Final
MEC Investigation Work Plan
Parcel 11
Revision 1.0

Fort Wingate Depot Activity
McKinley County, New Mexico

RE: APPROVAL WITH MODIFICATIONS
FINAL MEC INVESTIGATION WORK PLAN PARCEL 11 REVISION 1.0
FORT WINGATE DEPOT ACTIVITY
MCKINLEY COUNTY, NEW MEXICO
EPA ID# NM6213820974
HWB-FWDA-24-015

Figure 4.1

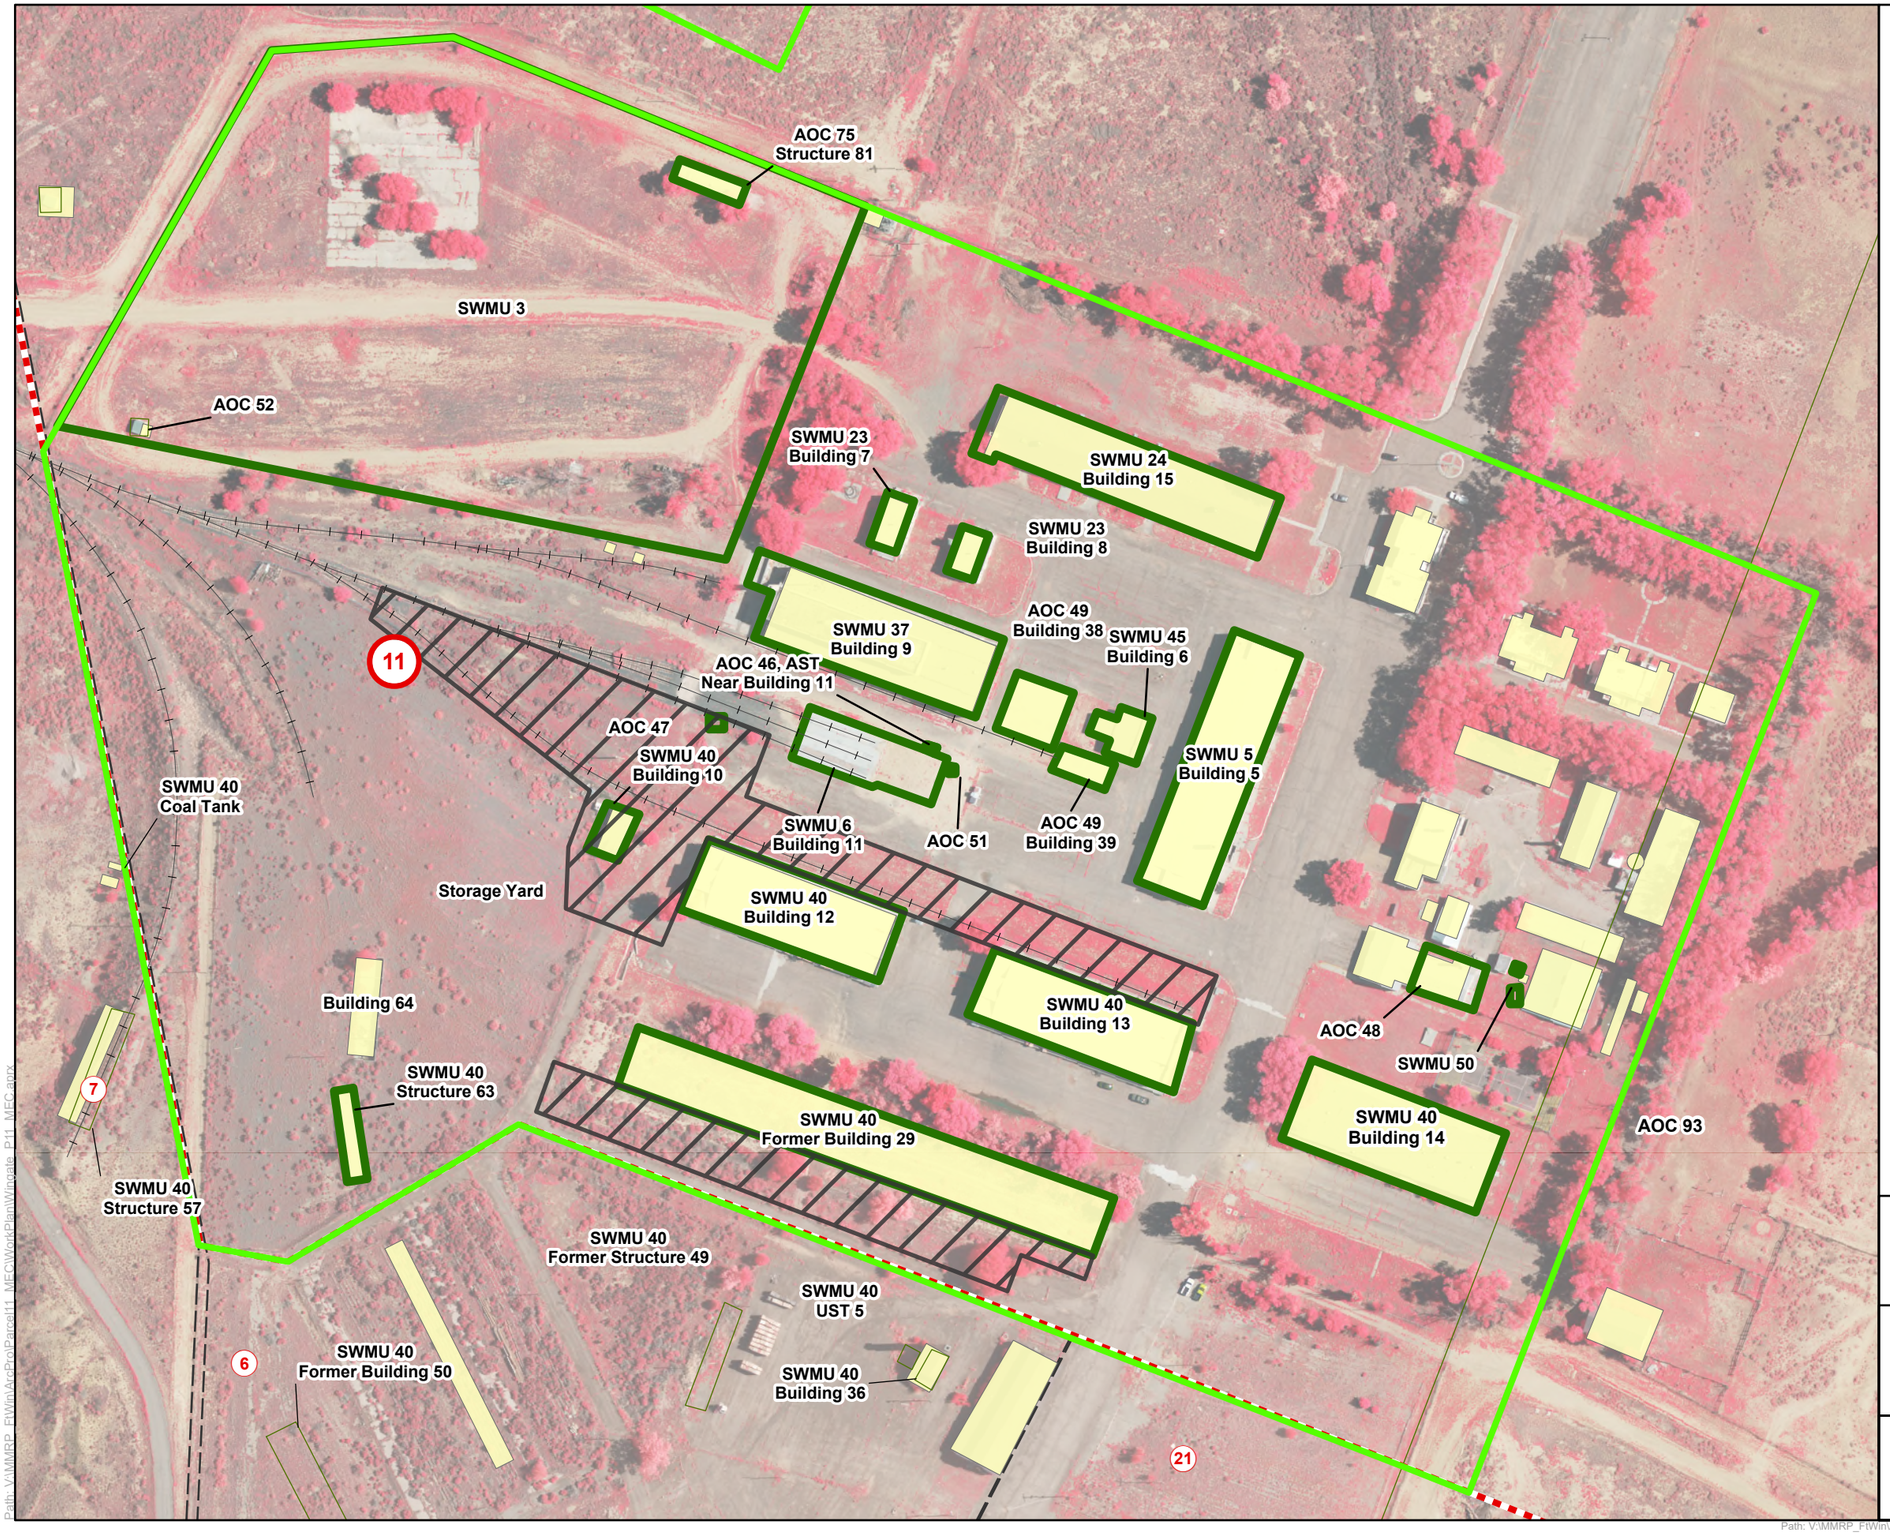
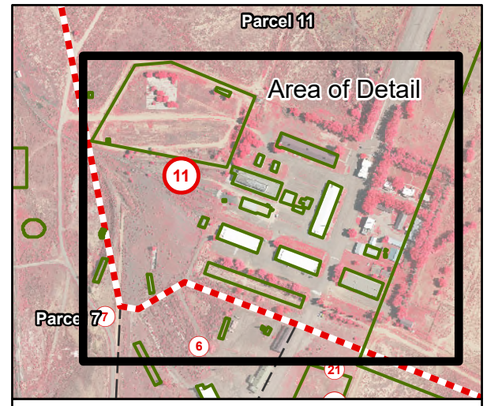
Permittee Statement: "The boundaries of the 2009 surveys adjacent to the SWMU 40 buildings/structures were based on proximity to specific buildings or structures. MEC contamination is not expected outside of these areas. Therefore, the SWMU 40 surveys will cover the same areas surveyed in 2009 (see Figure 4.1)."

NMED Comment: According to Figure 4.1, *SWMU 40 Structures*, the areas (a) surrounding Building 14, (b) between Buildings 12/13 and the former Building 29, and (c) surrounding structure 63 have not previously been investigated and are not proposed to be investigated in the Work Plan. Explain why these areas are not covered under this investigation in the response letter. Although the Permittee states, "MEC contamination is not expected outside of these areas," the presence/absence of MEC contamination is unknown because the areas were not previously investigated. Propose to investigate the areas in the revised Work Plan, as appropriate.

NMED Comment: The storage yard area depicted in Figure 4.1, *SWMU 40 Structures*, is not proposed to be investigated. Since the storage yard was used to store munitions, the area occupied by the storage yard must be investigated for the presence/absence of MEC. Revise the Work Plan accordingly.

NMED Comment: According to Figure 4.1, the footprint of the loading dock and its immediate surrounding areas are not proposed to be investigated. Since MEC may potentially be detected in the vicinity of the loading dock, propose to investigate the areas in the revised Work Plan, as practicable.

NMED Comment: According to Figure 4.1, *SWMU 40 Structures*, the areas (a) surrounding Building 14, (b) between Buildings 12/13 and the former Building 29, and (c) surrounding structure 63 have not previously been investigated and are not proposed to be investigated in the Work Plan. Explain why these areas are not covered under this investigation in the response letter. Although the Permittee states, "MEC contamination is not expected outside of these areas," the presence/absence of MEC contamination is unknown because the areas were not previously investigated. Propose to investigate the areas in the revised Work Plan, as appropriate.

NMED Comment: The storage yard area depicted in Figure 4.1, SWMU 40 Structures, is not proposed to be investigated. Since the storage yard was used to store munitions, the area occupied by the storage yard must be investigated for the presence/absence of MEC. Revise the Work Plan accordingly.

NMED Comment: According to Figure 4.1, the footprint of the loading dock and its immediate surrounding areas are not proposed to be investigated. Since MEC may potentially be detected in the vicinity of the loading dock, propose to investigate the areas in the revised Work Plan, as practicable.

Permittee Response: Concur. An approximately 36.5-acre geophysical investigation area is now proposed for the Administration Area in the vicinity of the munitions debris (MD) recovered near Building 12. The survey area includes two former storage yards and most of the SWMUs and AOCs in Parcel 11, except for SWMU 10. It includes all areas where the presence of MEC could be reasonably suspected in Parcel 11 outside of SWMU 10. The Work Plan has been extensively revised to address this, including the Executive Summary, Section 1.0, and Section 4.0. Figures 1.3 and 4.1 have also been revised.
